A7. POST-APPLICATION DISCUSSION

COMMENTS BY THE PRIMROSE HILL CONSERVATION AREA ADVISORY COMMITTEE

Primrose Hill Primary School Princess Road NW1 8JL Listed Building PRE-APP

A7.2.1 10.05.16. Robert Loader and David Walter met Tanya Skelli-Yaoz and Sarah Freeman at LB Camden to present the proposals. The points arising from the meeting are set out below.

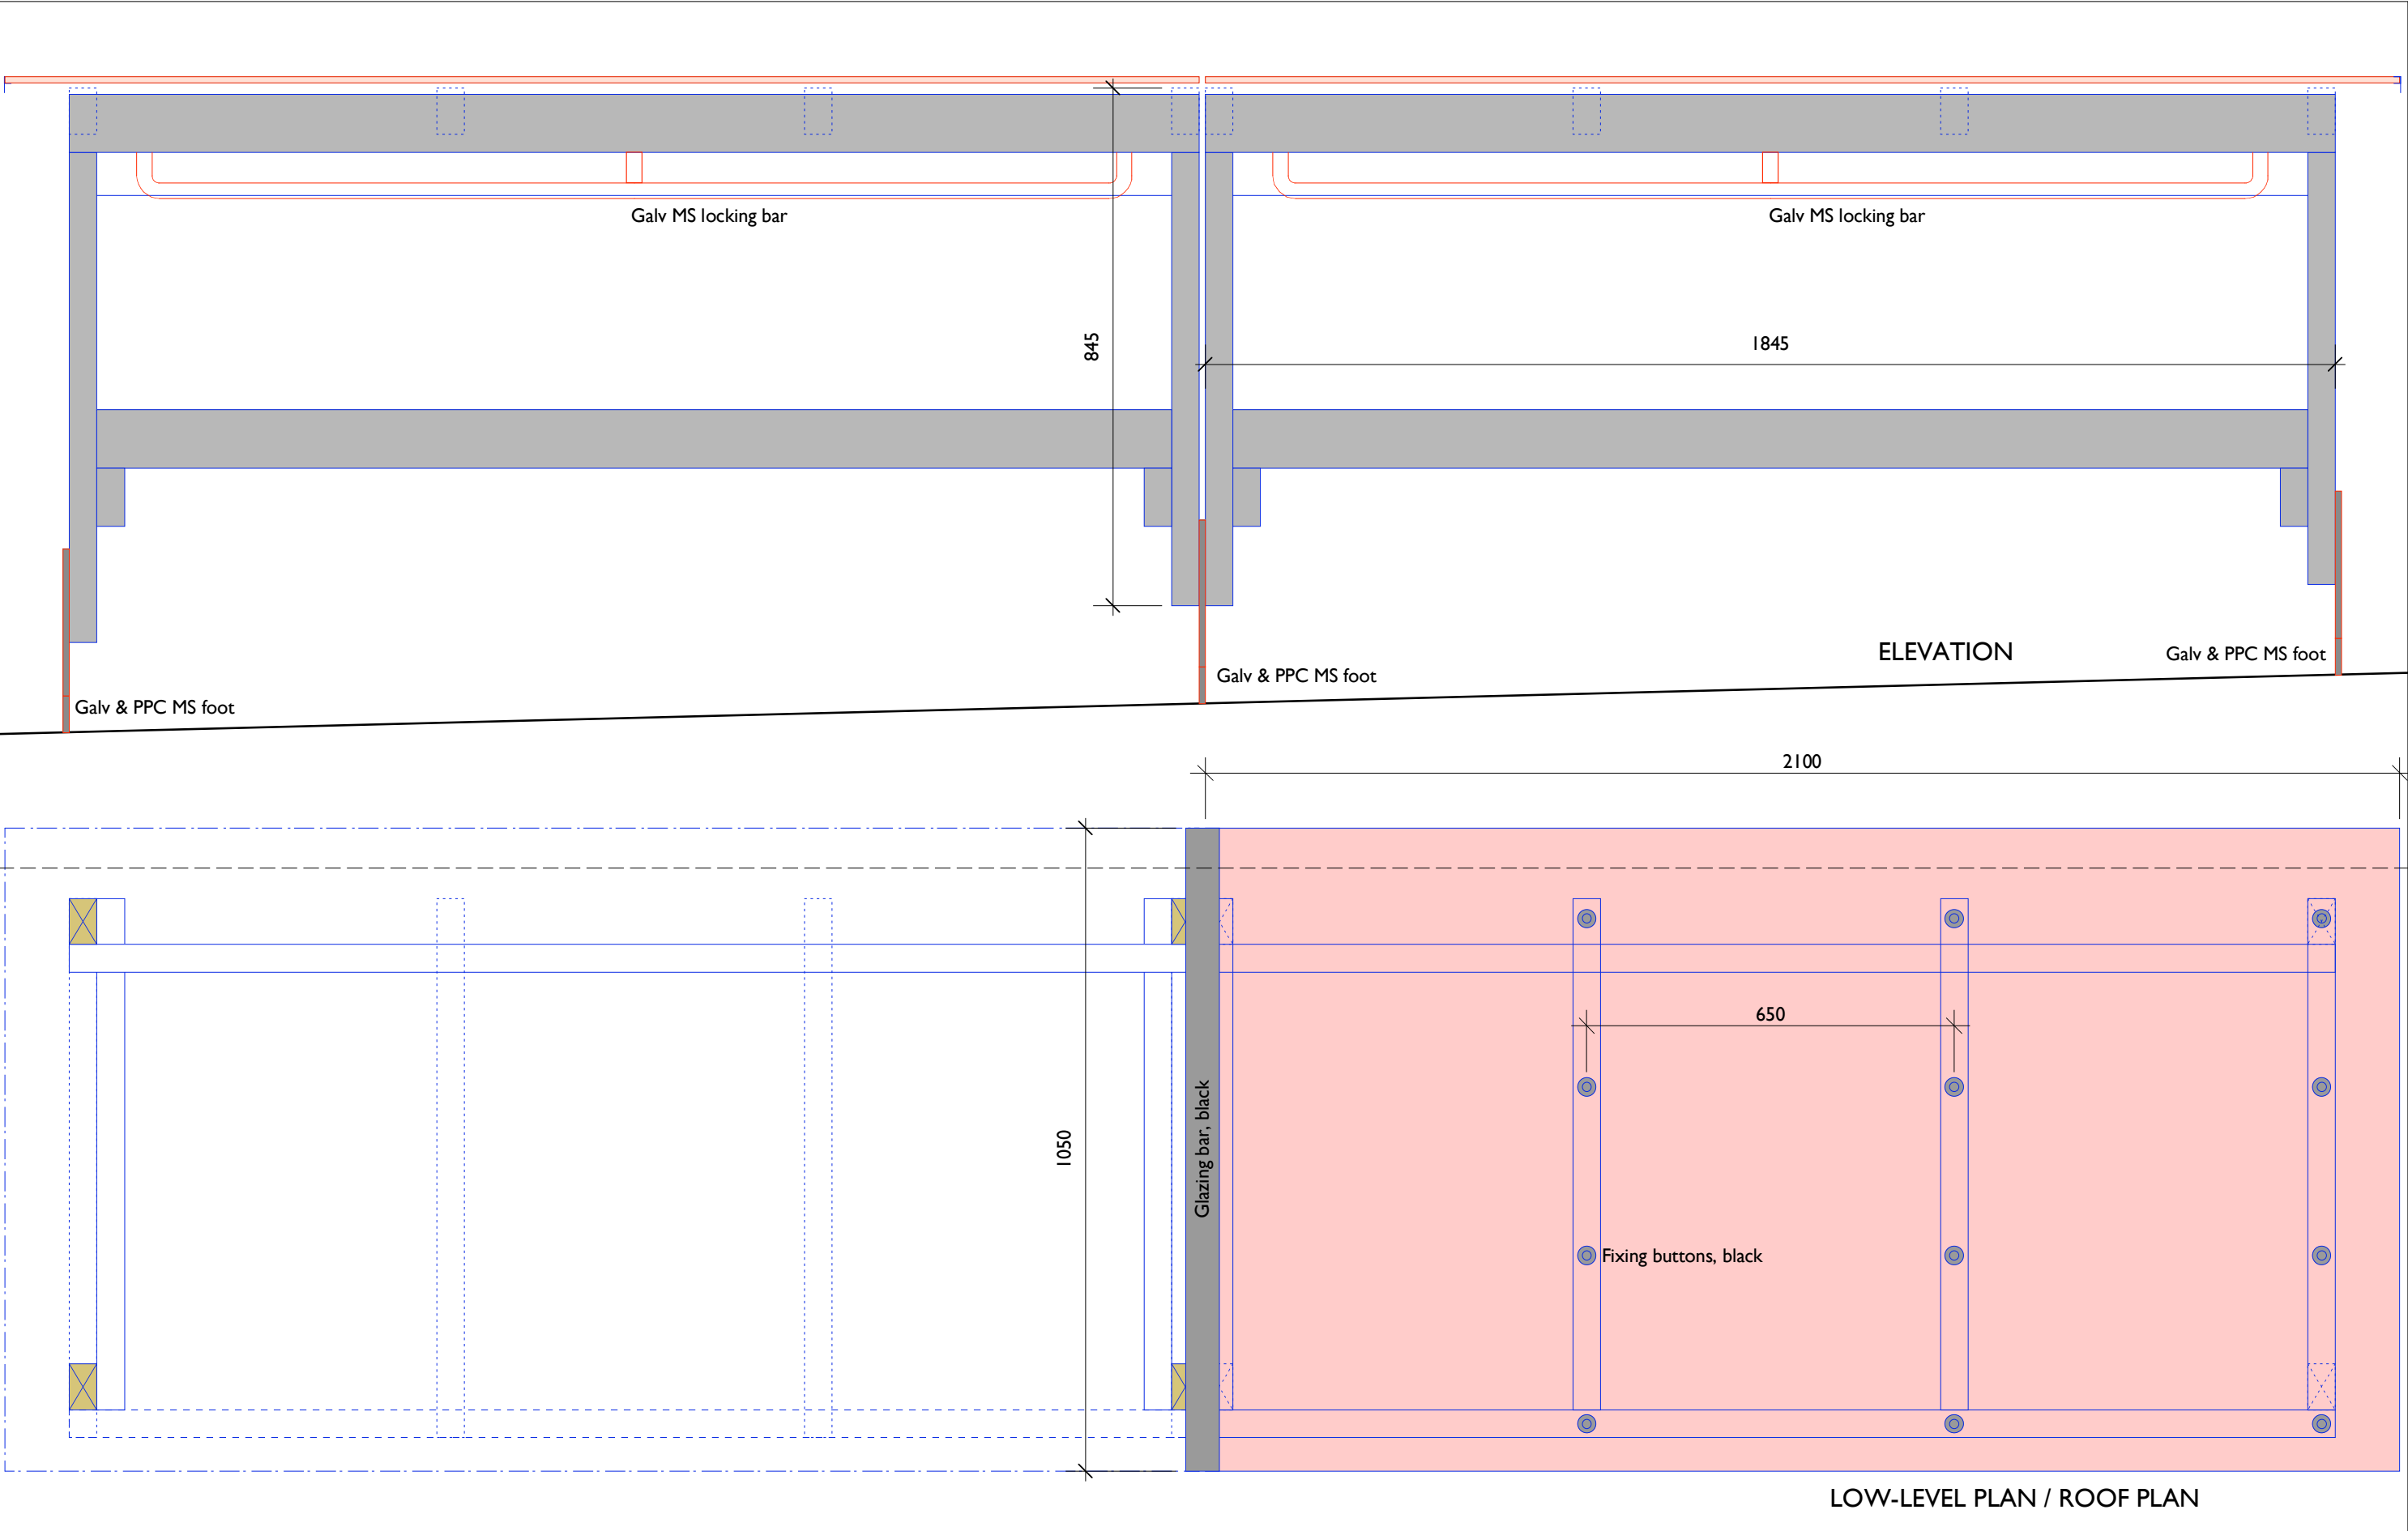
At the front of the School House, we would need to see details of the treatment of the foot of the gate to lower the gate to the reduced level of the access ramp. We accepted that the access ramp was a good solution to the need to provide wheeled access. We would object to the location of a buggy store as shown. The front area of the house is a key element in the Listed Building and its setting, as well as contributing to the character and appearance of the conservation area.

16. More detail on the Buggy Store at the front of the Caretaker's House to be provided.

Response: Further detail on the Buggy Store at the front of the Caretaker's House is attached below: PRPS PR 525_G and PRPS PR526_G.
